P1 DROPPER SERUM BOTTLE - OWNER VISUAL REVIEW BOARD

PROVISIONAL_BEST_EFFORT_GEOMETRY_PILOT | geometry authority: PROVISIONAL_OWNER_MEASURED_PLUS_INFERRED | manufacturing authority: NOT_ESTABLISHED
owner approval: PENDING_VISUAL_REVIEW | GATE_2: BLOCKED | photographs are perspective + uncalibrated - NO calibrated overlay accuracy is claimed
photographs are never stretched: uniform scaling and whole-image crops only | THREAD_GEOMETRY_NOT_MODELLED | NOT_MANUFACTURING_AUTHORITATIVE
P1 V2 REVISION - V1 owner visual review: visual fidelity FAIL + material realism FAIL; V2 revises bulb/shoulder/collar/base + materials; V1 preserved at p1_pilot/2026-08-04/

MATERIAL PREVIEW

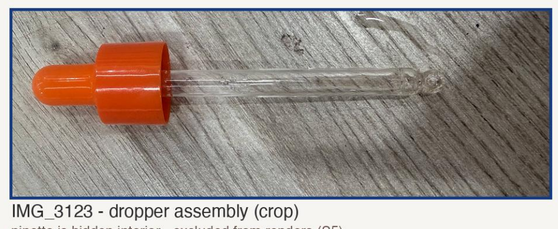
corrected material preview (owner-corrected facts 2026-08-04)
bottle GLASS/MATTE/TRANSLUCENT ORANGE | collar+bulb PLASTIC/GLOSSY/ORANGE (bulb OPAQUE)

V1 vs V2 silhouettes (renders, aligned by construction)

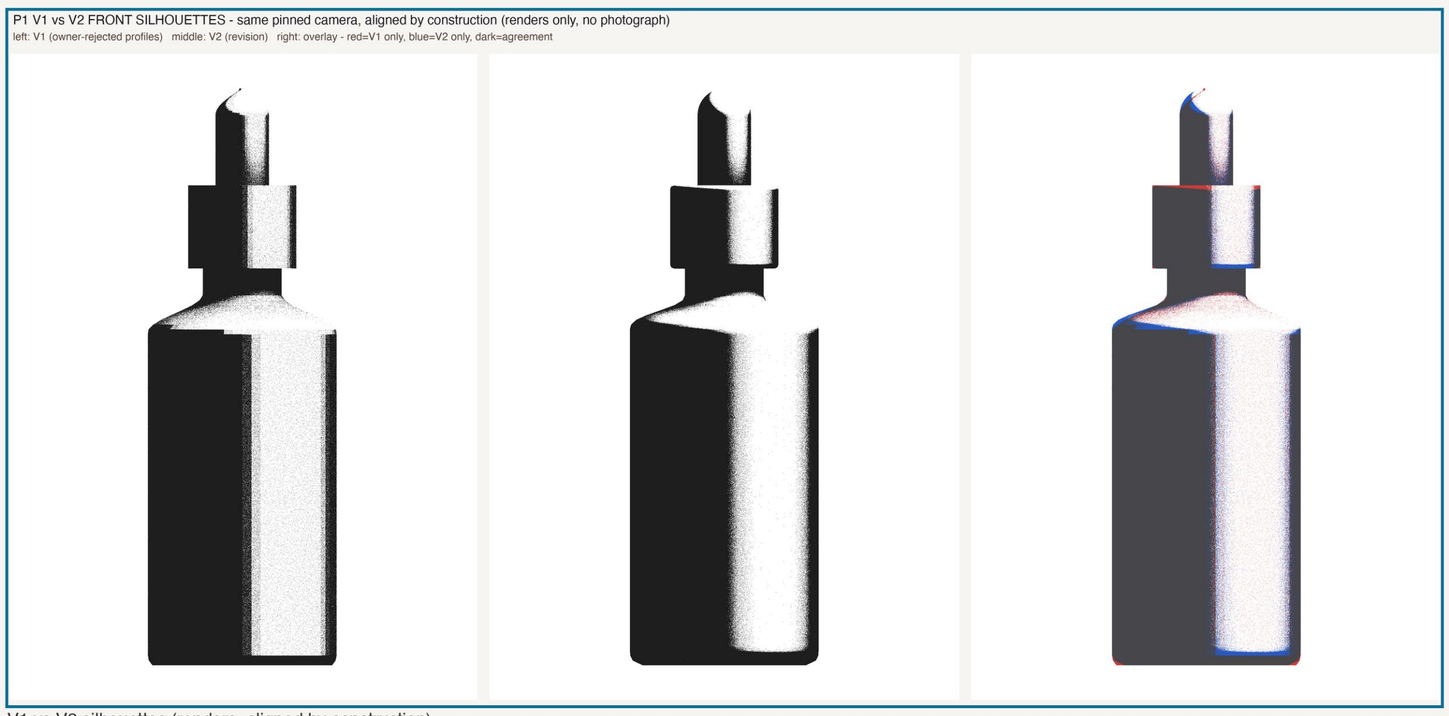
shoulder: V2 C2 smootherstep + fullness bias (VISUAL_ESTIMATE, MEDIUM; V1 cosine model owner-rejected)
bulb: V2 rounded capsule, TRUE hemispherical dome (VISUAL_ESTIMATE, MEDIUM; V1 conical cap owner-rejected)
neck finish: GL18/DIN 168 class (ONLINE_ANALOGOUS_REFERENCE, MEDIUM, NOT_EXACT_MATCH); pitch 3.0 from the DIN table
base bottom radius 2.5 + weighted settle; collar edge round 0.8; bottom glass 0.8 (GENERIC_RENDERING_DEFAULT, LOW)

P1 V1 vs V2 FRONT SILHOUETTES - same pinned camera, aligned by construction (renders only, no photograph)
left: V1 (owner-rejected profiles) middle: V2 (revision) right: overlay - red=V1 only, blue=V2 only, dark=agreement

owner photo vs V2 (qualitative, uncalibrated)

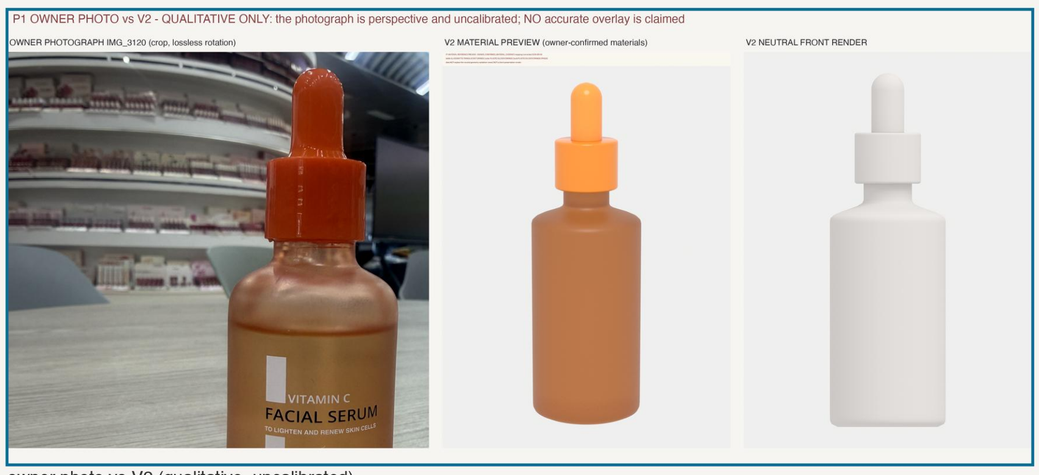
P1 OWNER PHOTO vs V2 - QUALITATIVE ONLY: the photograph is perspective and uncalibrated; NO accurate overlay is claimed
